WORK INSPECTION REQUEST (WIR) FORM

Contractor:	HAIF-FREYSSINET JV
Project:	RA2RC
Contract No.:	QPMO-410-CT-00618
Work Inspection Request Number:	QRXM114000-HFC-TEC-WIR-ITS-02-RO5-00002

Inspection request for Installation of Variable Message Sign (VMS)-5nos and 7mtr ITS Pole-5nos VMS-01,VMS-02 ,VMS-03 ,VMS-04 ,VMS-05 .Main Line-02 and Spiliting.

Project Name: Package 3 - Interim Road Access to Resort Core	**Project Code:** QRXM114000
**Location: RA2RC ** Qiddiya INTERM ROAD	**Date:** 14-February-2026
Document Title: Method of Statement for Installation and Commissioning of Intelligent Transportation System Equipment and Devices.	**Ref No: QRXM114000-HFC-TEC-MST-ITS-02-RO5-00001** **Rev No:** 00

Drawing title:
ITS SHOP DRAWINGS
ITS LAYOUT PLAN

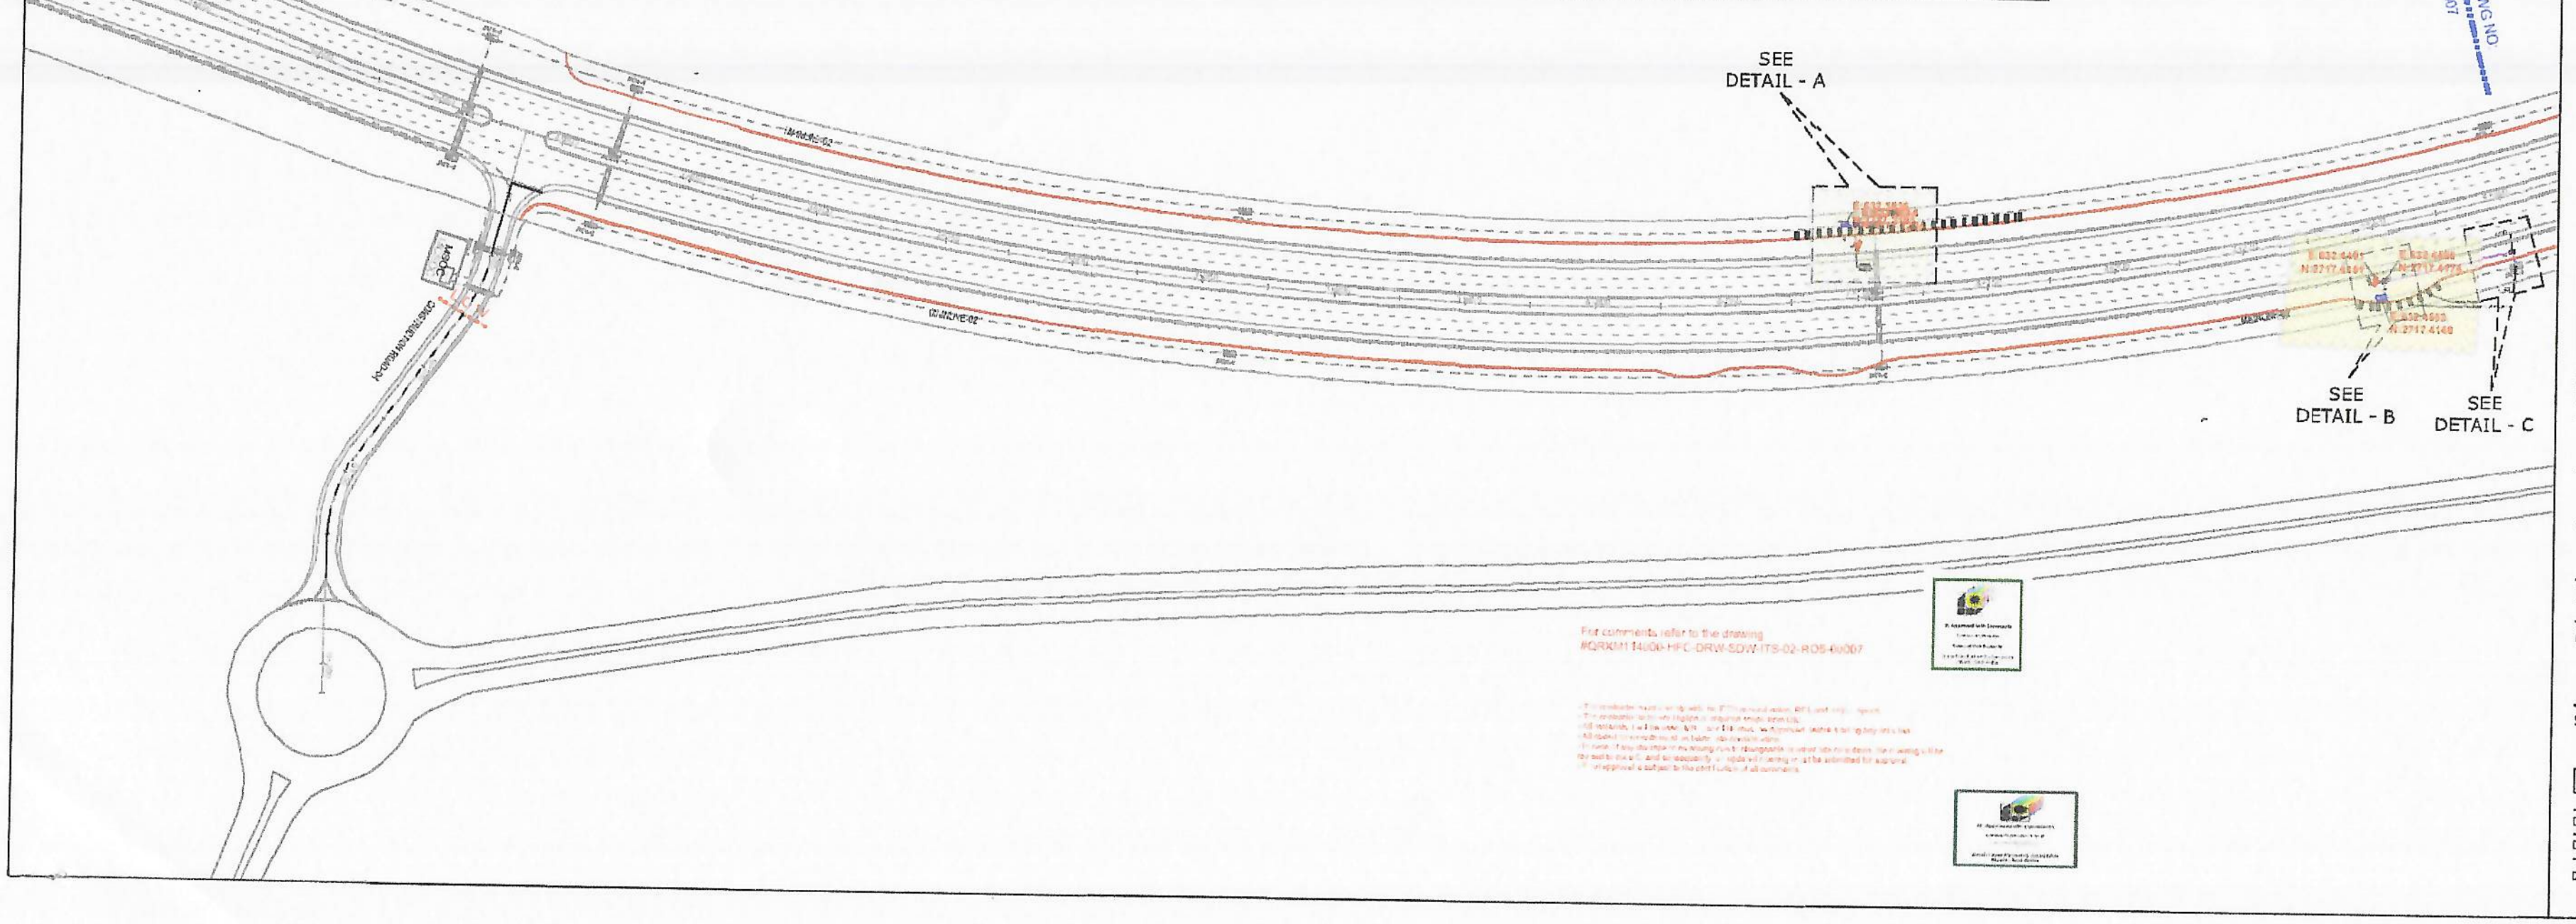
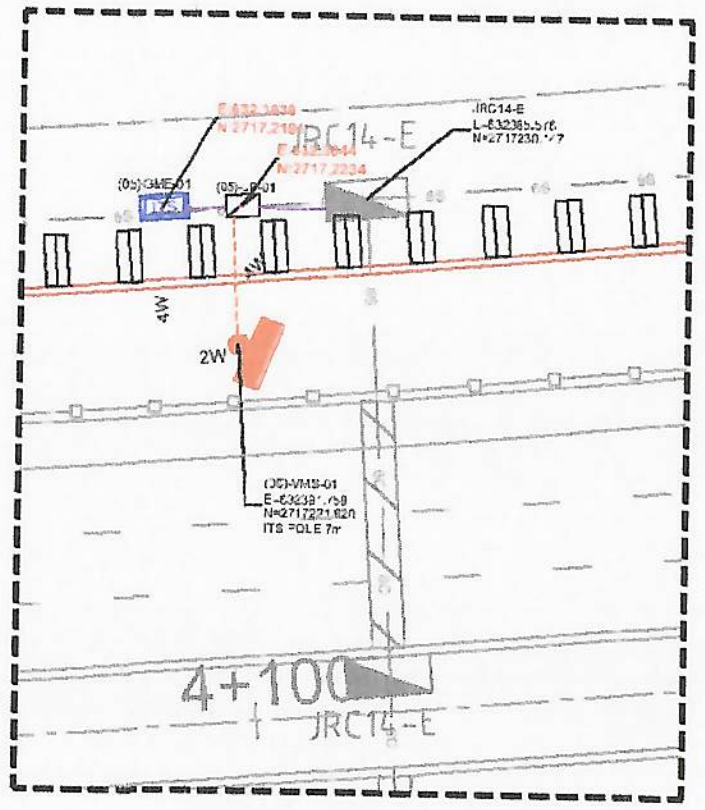
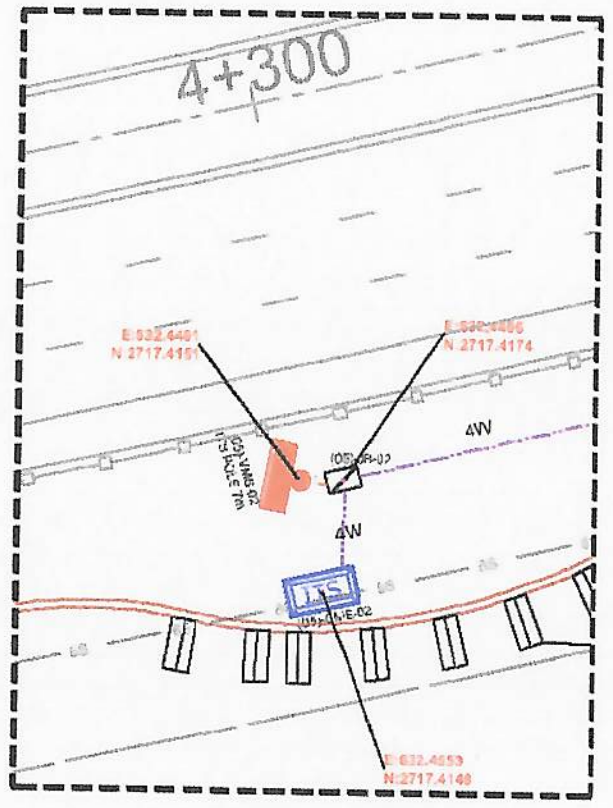
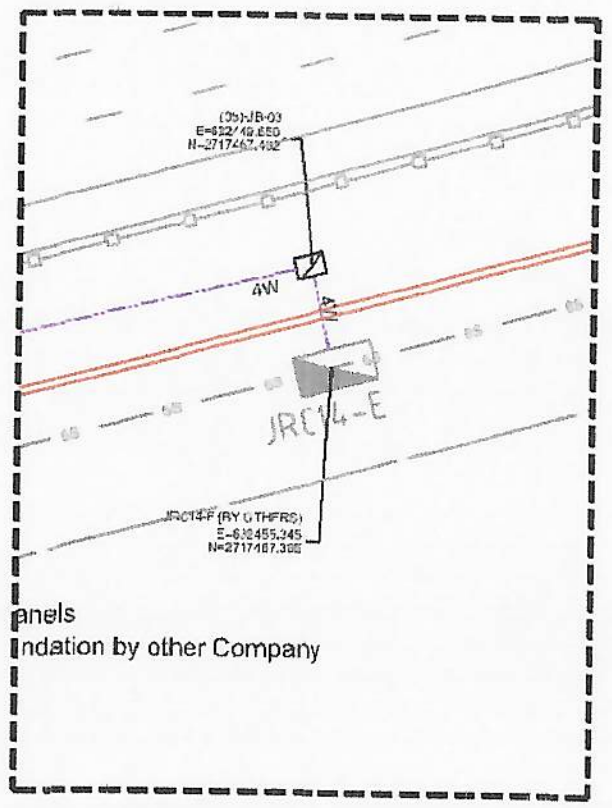
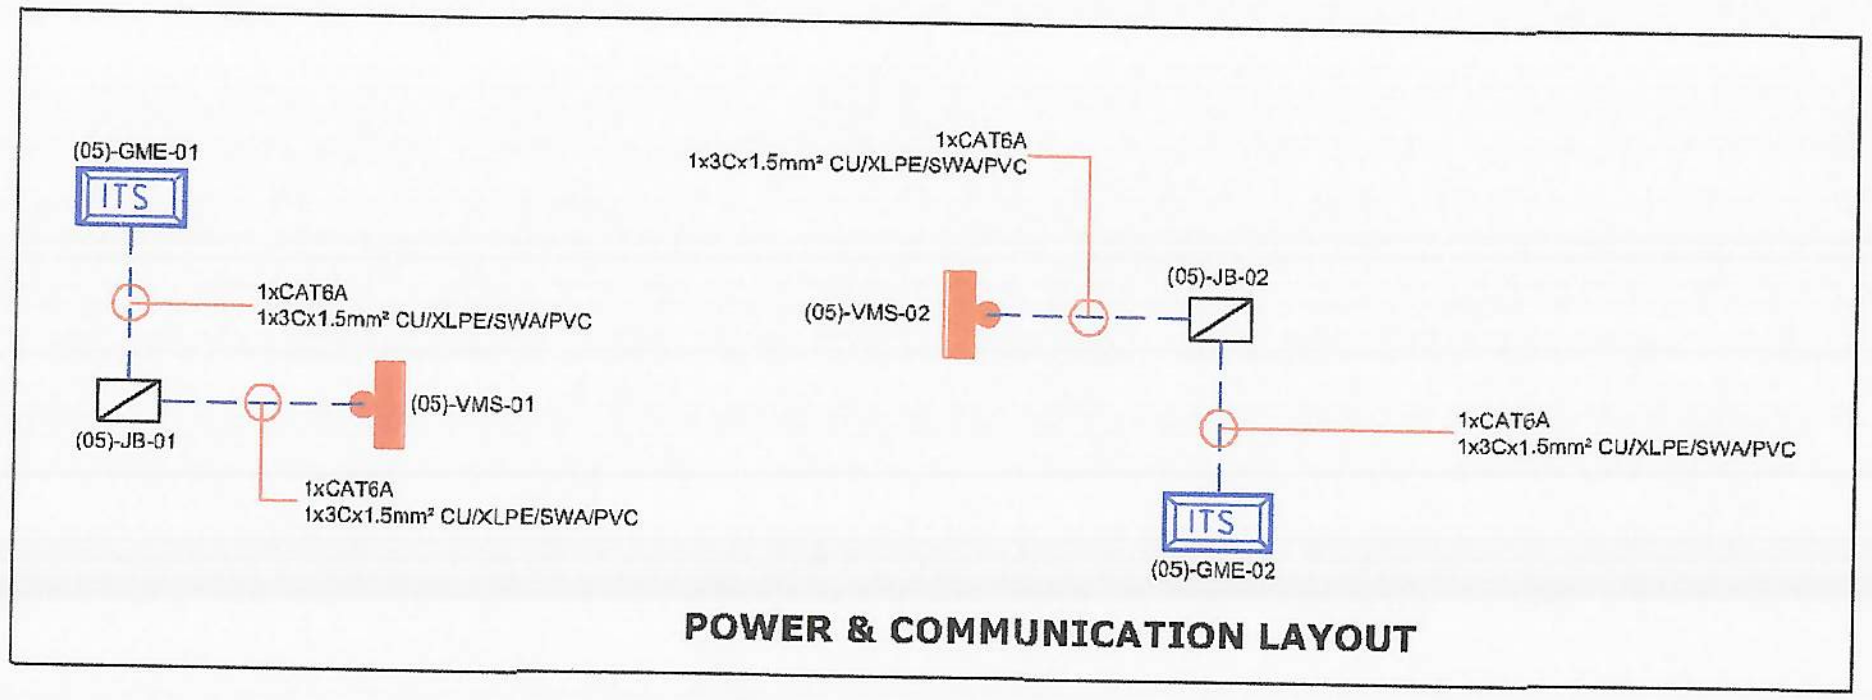
For comments refer to the drawing
#QRXM114000-HFC-DRW-SDW-ITS-02-RO5-00007

VARIABLE MESSAGE SIGN (VMS) ON 7m ITS POLE TYPICAL DETAILS

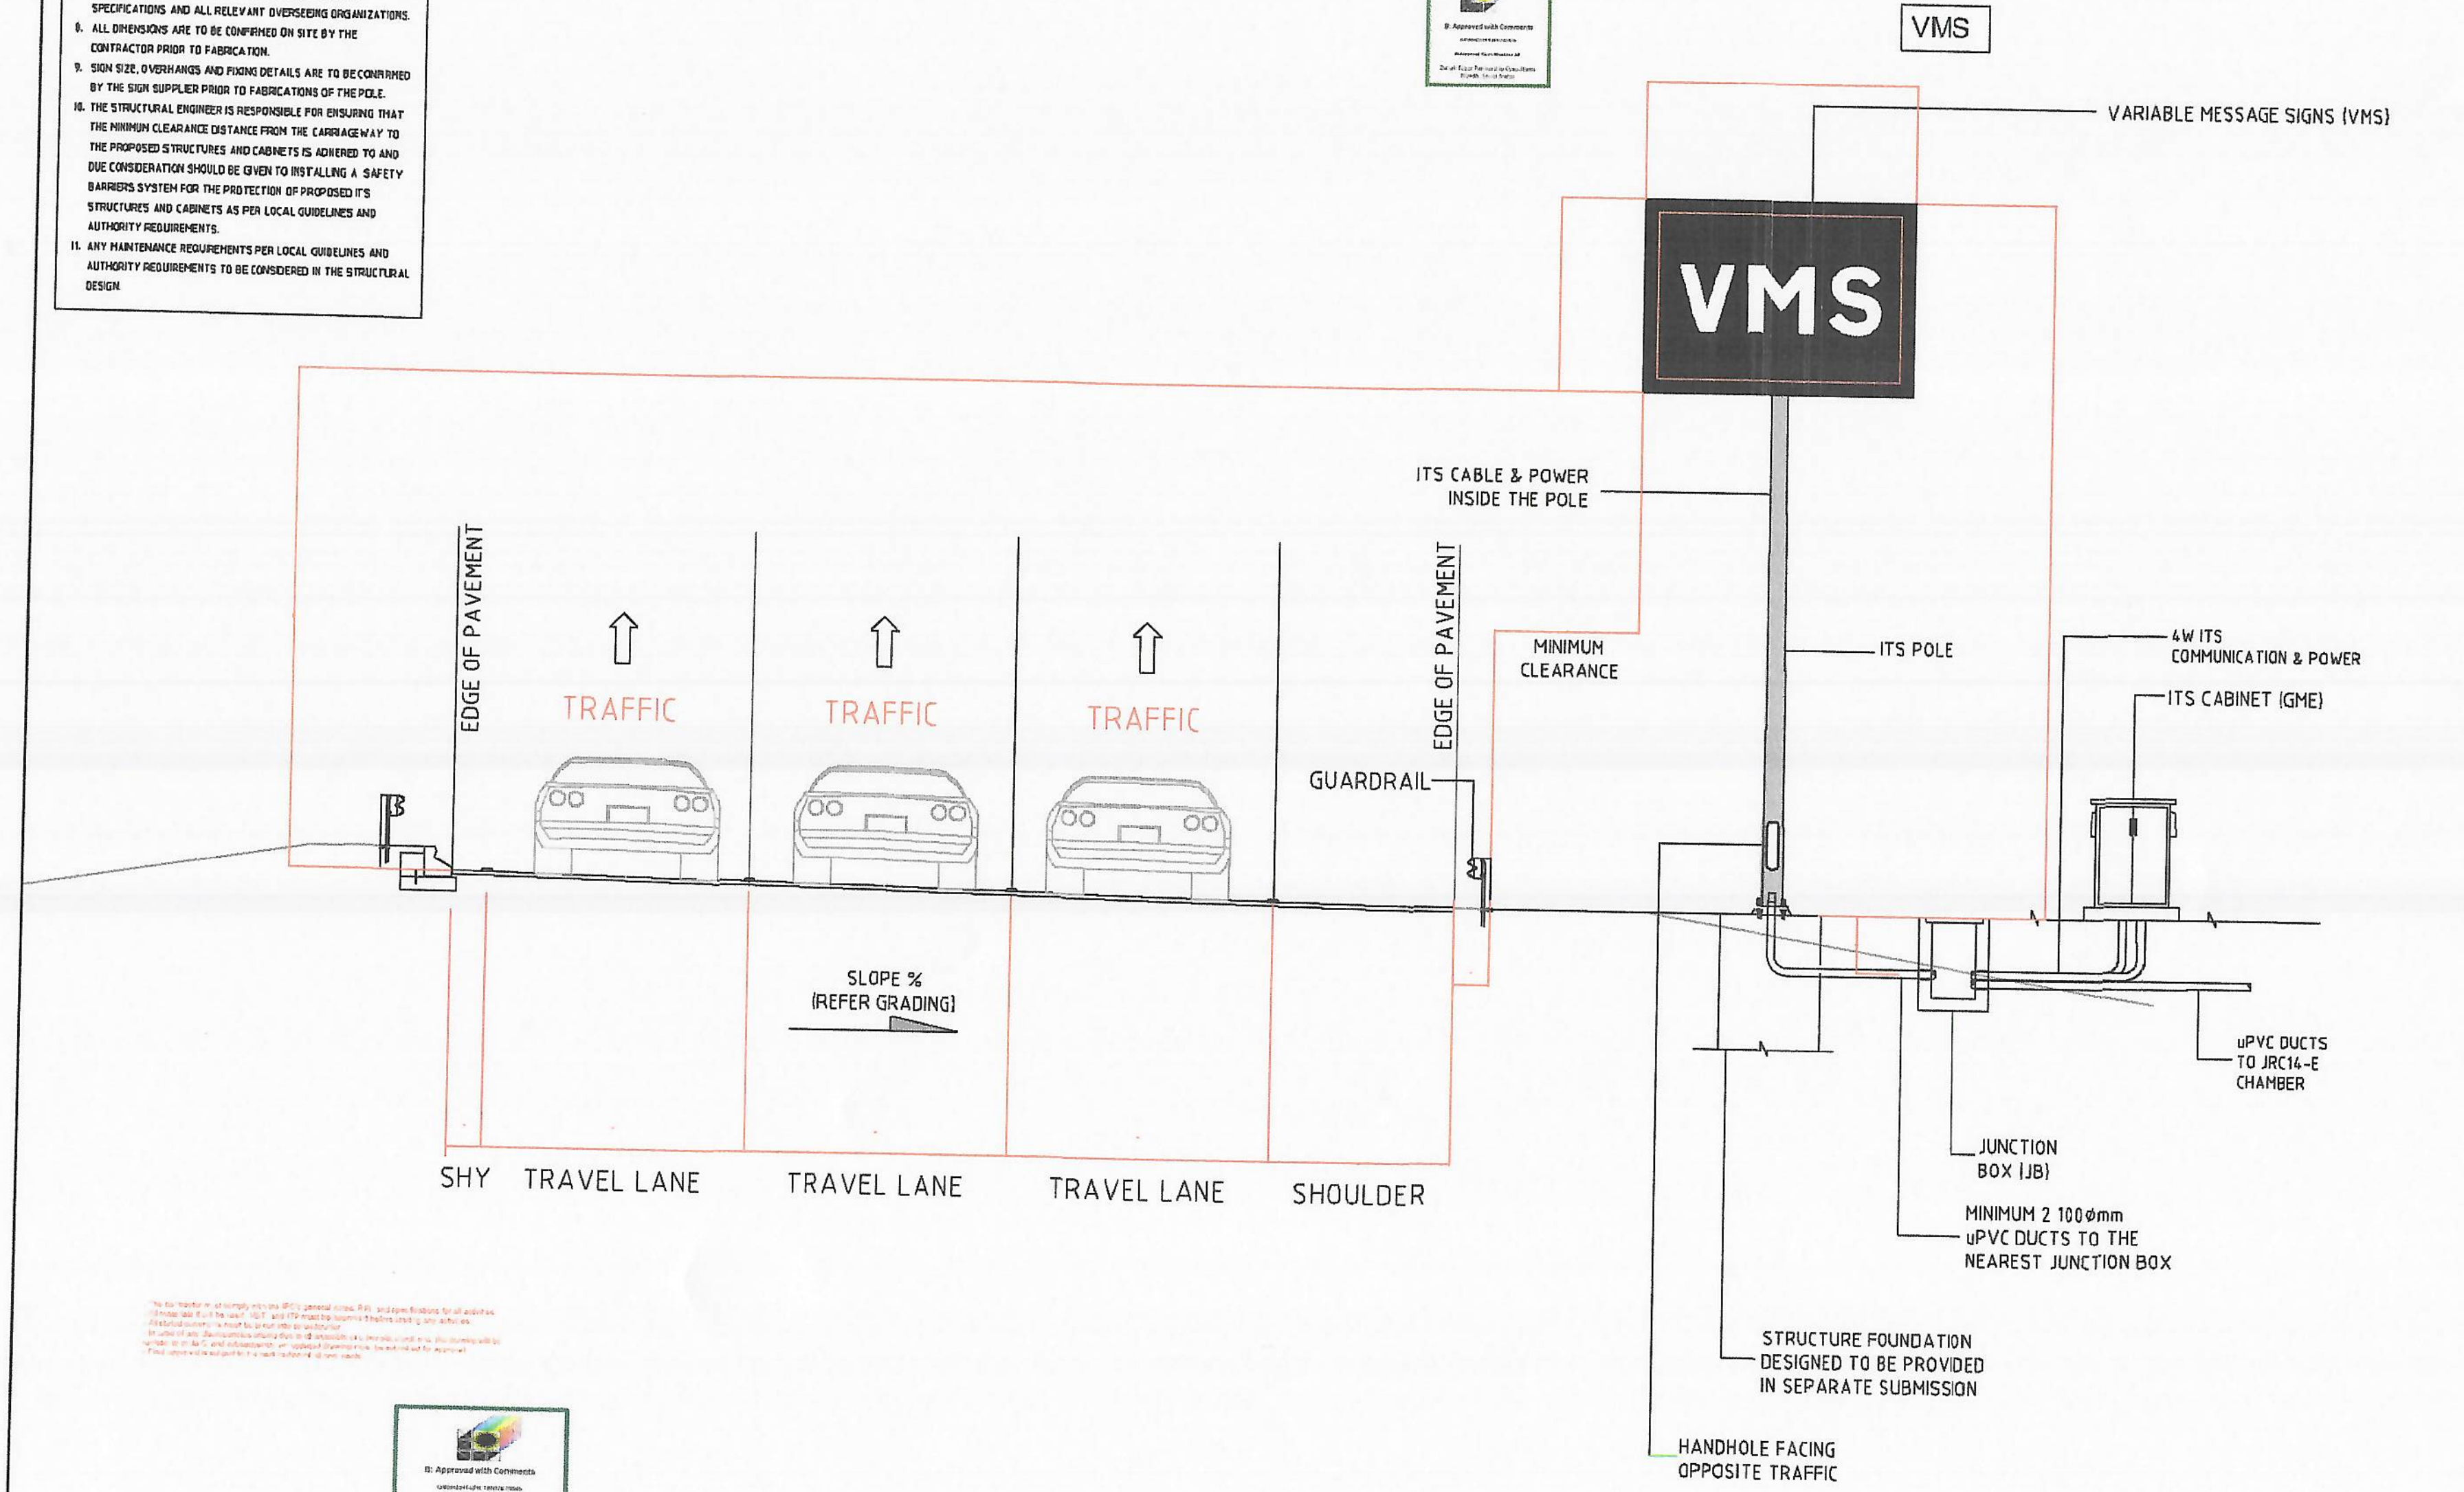
1.Size of VMS shall be as per approved material submittal.
2.The mounting height shall be as per site condition and QIC recommendation
